# UNITED STATES PATENT AND TRADEMARK OFFICE

APPLICATION NO.	FILING DATE	FIRST NAMED INVENTOR	ATTORNEY DOCKET NO.	CONFIRMATION NO.
09/748,277	12/27/2000	Jae-Lag Ma	8733.363.00	4729

# Office Action Summary

FIG. 3

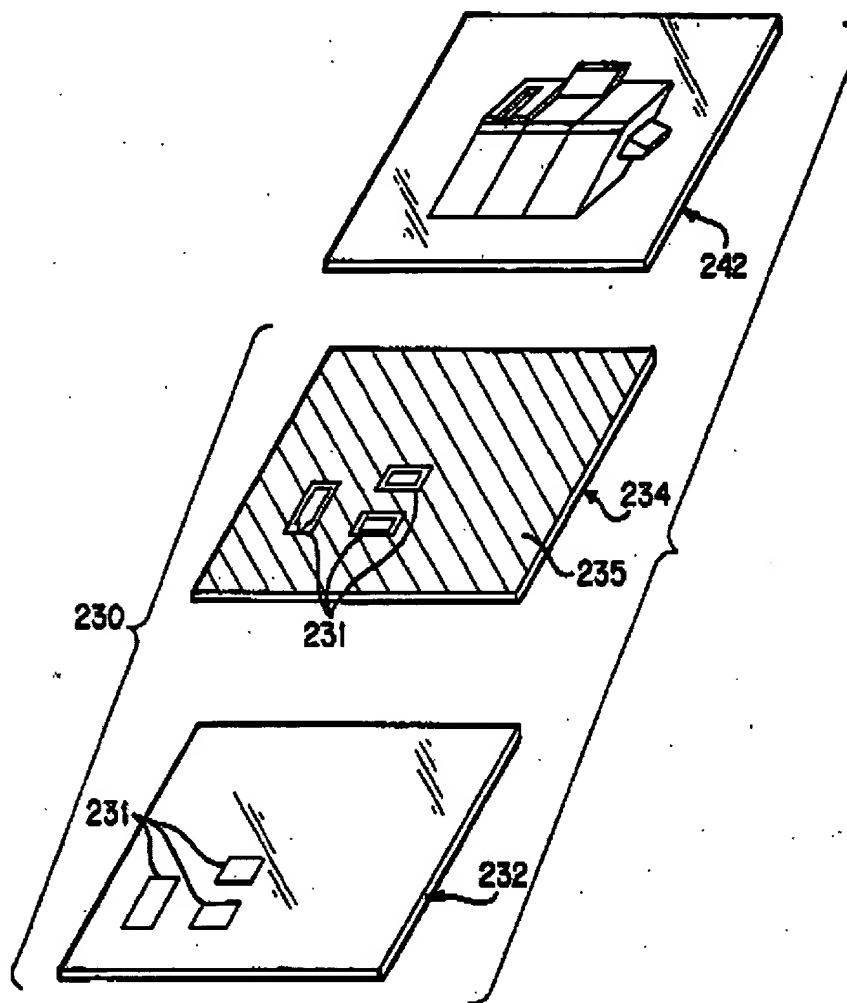
As to claims 1, 4, and 5, Dingwall teaches in Figures 2 and 3 (col. 5, lines 33-40 and col. 7, line 60 through col. 8 line 28), a liquid crystal display (LCD) device, comprising: an upper polarizer, 237a; an upper substrate under the upper polarizer, 236a; a liquid crystal layer under the upper substrate (between substrates); a lower substrate, 236b, under the liquid crystal layer; a lower polarizer, 237b, under the lower substrate, the lower polarizer including at least one opaque surround or black mask,

235, (Applicant's light shielding film) in a peripheral portion, formed in the four peripheral sides of the lower polarizer (as illustrated in Figure 3); and a backlight device, 224, positioned under the lower polarizer (see also Figure 4).

As to claims 2 and 3, Dingwall teaches (col. 8, lines 11-28) a liquid crystal display (LCD) device of claim 1, wherein the at least one opaque surround or black mask, 235, (Applicant's light shielding film) is formed by a photographic process, by offset lithography (Applicant's coating), or by screen printing (Applicant's printing) black mask materials that absorb the light (col. 8, lines 29-33).
